SHURE®

October 4, 1999

Re: FCC ID DD4UC2B
Correspondence Reference Number: 9870
731 Confirmation Number: EA94794
Date of Original E-mail: 09/29/1999

FCC ID DD4UC1B
Correspondence Reference Number: 9790
731 Confirmation Number: EA94793
Date of Original E-mail: 9/23/99

LEVEL
FREQUENCY
SPAN/DIV
REF 20DBM
CEN 703.875MHZ
50KHZ
15KHz @ 16dB > 50% Modulation
Input level = -44dBV
DBM
20
10
0
-10
-20
-30
-40
-50
-60
TEK
492AP
10DB/
VERTICAL
DISPLAY
50DB
RF
ATTENUATION
0-1.8
FREQ
RANGE
1KHZ
RESOLUTION
BANDWIDTH

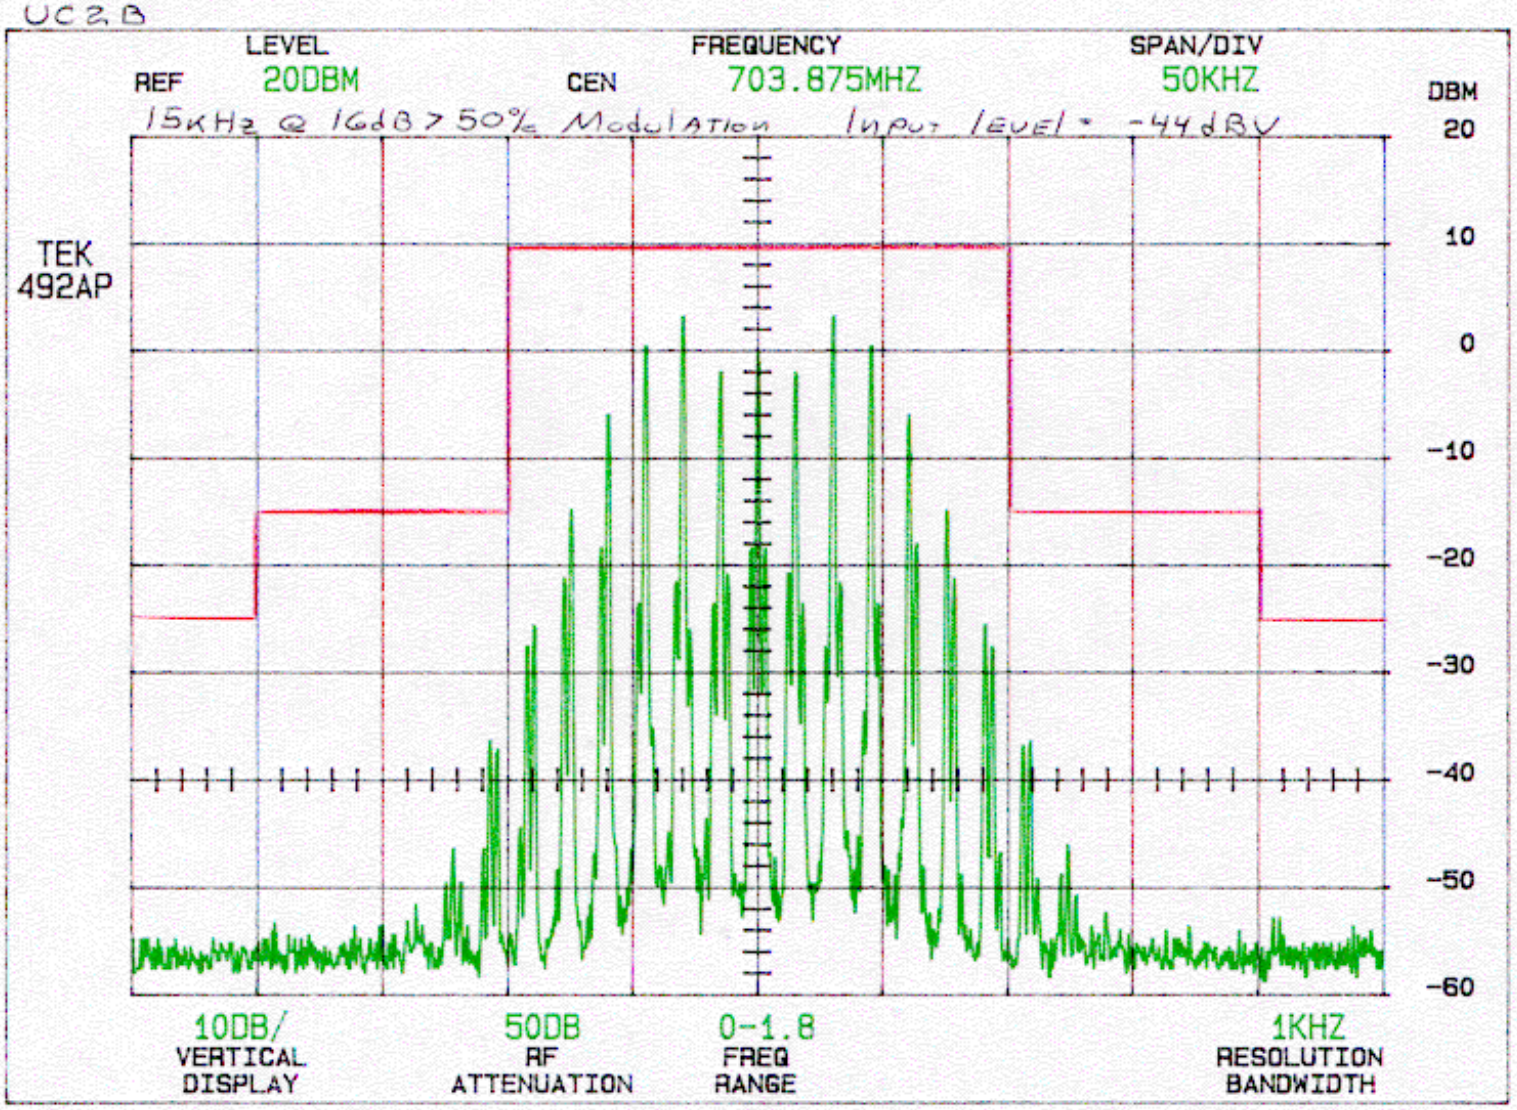
1. The occupied bandwidth plots were obtained by following the procedure detailed below, which was previously recommended by your office:

First, the modulation frequency of maximum response was established by supplying an audio signal to the transmitter input, at a level well below the onset of limiting, and varying its frequency over the entire audio range until the point was found where maximum deviation occurs. Then, the audio signal was adjusted so as to produce 50% modulation (22.5 kHz deviation, in the case of the UC2B) on a Boonton Model 8200 modulation analyzer, and the audio input level was recorded. Next the audio frequency was changed to 2500 Hz, and the input level was increased by 16 dB over that which was recorded at the frequency of maximum response. A plot was then made of the resulting emission. In addition, several other plots were made at other representative modulation frequencies, using the same input level, so as to demonstrate the transmitter's modulation characteristics. A reference plot was also made with no audio modulation applied.

Note that this transmitter incorporates a 32.768 kHz continuous pilot (control) signal (referred to by Shure as "Tone Key"). Note also, that the Boonton modulation analyzer employs a broadband demodulator. Thus, the deviation of the pilot signal affects the setting of the 50% modulation point. This is probably why the modulation plots appear to be undermodulated. A percentage of the deviation is due to the pilot signal.

UC2B Input Level Vs Deviation
+/-kHz Deviation
80
75
70
65
60
55
50
45
40
35
30
25
20
15
10
5
0
-80
-70
-60
-50
-40
Input Level dBV
80Hz
500Hz
2.5kHz
10kHz
15kHz

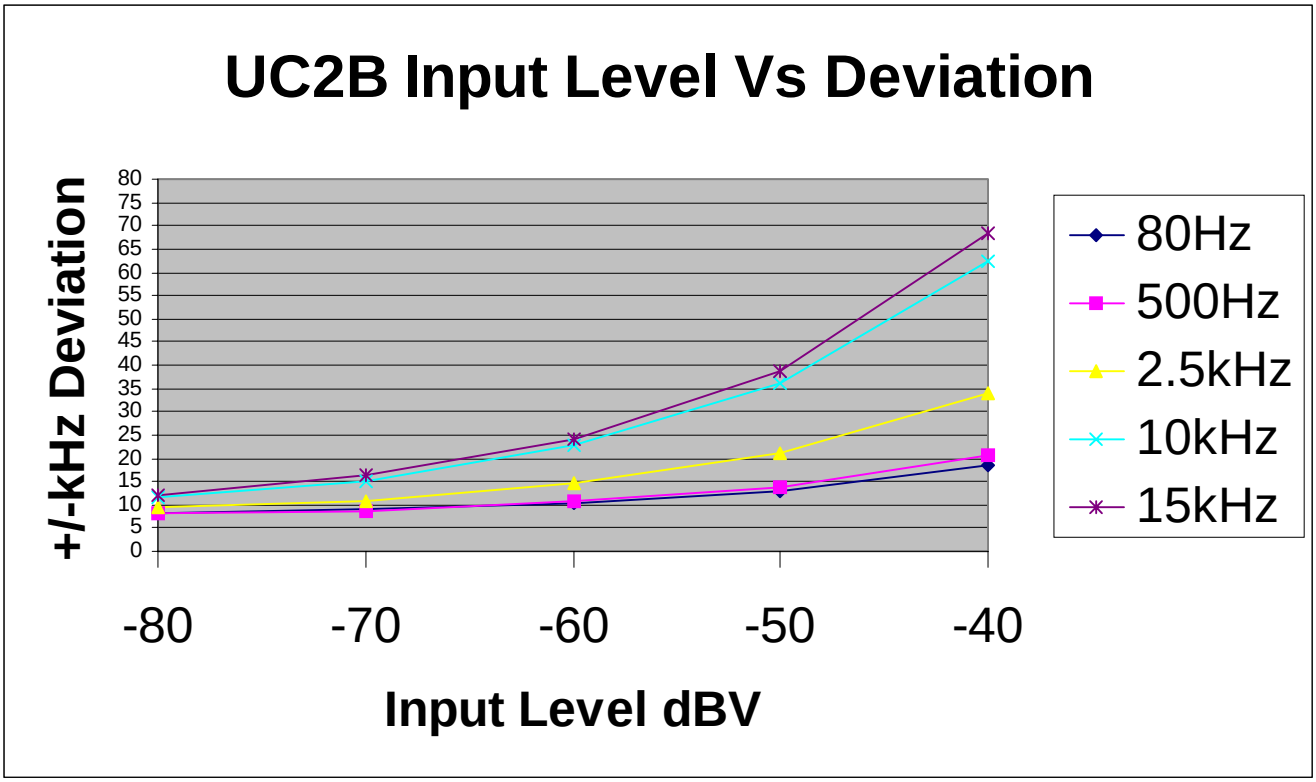
2. The modulation limiting plot was intended to demonstrate the transmitter's modulation characteristics at input levels up to, and beyond input levels for normal operation. From the occupied bandwidth plots, you will note that the audio input level for 16 dB above 50% modulation at the frequency of peak response is –60 dBV, (or –55.5 dBV if deviation due to the pilot signal is disregarded). The peak deviation is dependent upon the modulation frequency due to pre-emphasis; however it would be close to 40 kHz at the frequency of maximum response if the pilot signal is included in determining the input level for the occupied bandwidth. Shure uses 45 kHz as the nominal 100% modulation point.
